## DEPARTMENT OF PLANNING AND COMMUNITY DEVELOPMENT STAFF REPORT

<b>PLANNING COMMISSION AGENDA ITEM 4:</b>		
<b>Project Name:</b>	<b>SCE Subdivision, Lots 1 and 2 #DP-08-05</b>	
<b>Prepared By:</b>	Jason K. Peasley, City Planner (Ext. 229)	 <p style="font-size: small; margin-top: 10px;">Location: Steamboat Highlands (Existing Ski Country Building) 2135 Burgess Creek Rd.</p>
<b>Through:</b>	John Eastman AICP, Planning Services Manager (Ext. 275)	
<b>Planning Commission (PC):</b>	May 14, 2009	
<b>City Council (CC):</b>	June 2, 2009	
<b>Zoning:</b>	Gondola – One (G-1) and Residential Estate One (RE-1)	
<b>Applicant:</b>	Ski Country, LLC, Jim Reily Managing Partner, c/o Vertical Arts, PO Box 774842, Steamboat Springs, CO 80477 Contact: Brian Bavosi (970) 871-0056	
<b>Request:</b>	Development Plan for a 328,610 square foot condominium hotel consisting of 14,418 square feet of commercial space and 136 dwelling units. This application also includes a PUD to allow variances to exceed the allowable building height by 45' and encroach into waterbody and side setbacks.

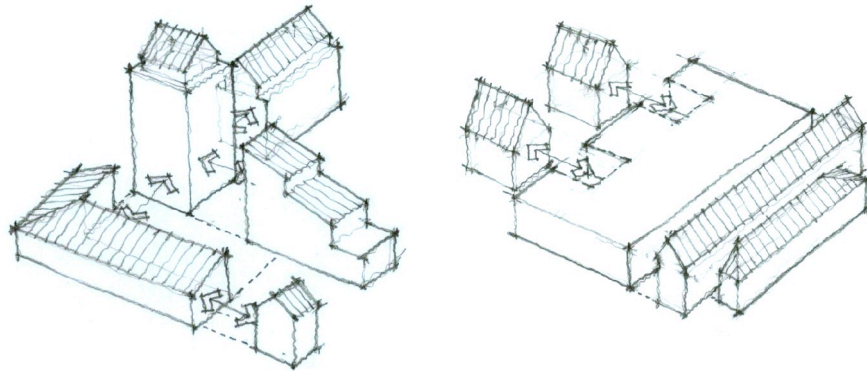
*Staff Analysis: Consistent;* The Steamboat Highlands project works to reduce its overall mass foremost by breaking the building into three towers sitting atop a 2-3 story plinth. The buildings include substantial stepdowns at each end to transition well to adjacent development. In addition to numerous building setbacks, the building includes multiple awnings, both traditional and angular, that add interest and articulation.

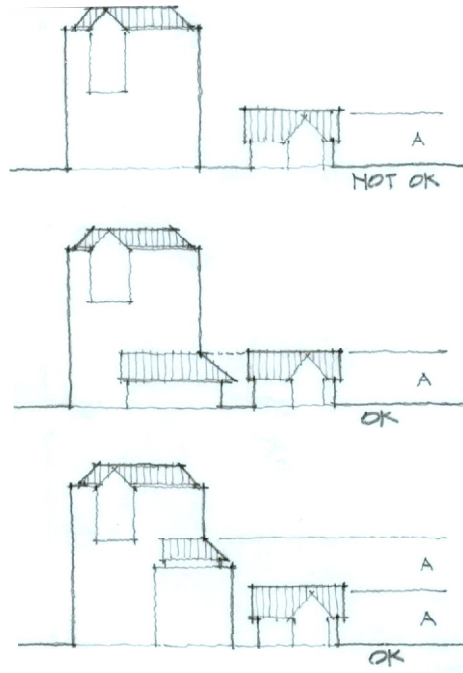
Staff Analysis: **Consistent;** All building facades have received a high degree of detail with no blank walls present. All facades include extensive articulation.

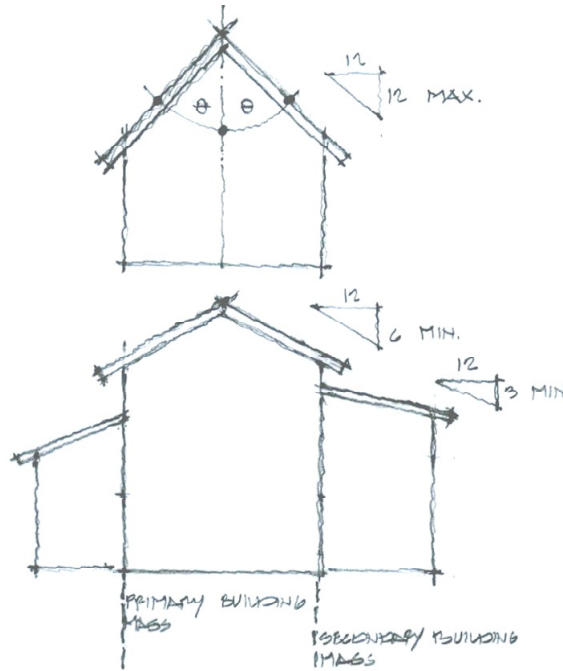
**Staff Analysis: Consistent;** The roof plan demonstrates a variety of roof forms with most roof pitches being 6:12 with smaller shed roofs at 3:12. The Southern tower includes a portion of flat roof that does not exceed the 50% maximum.
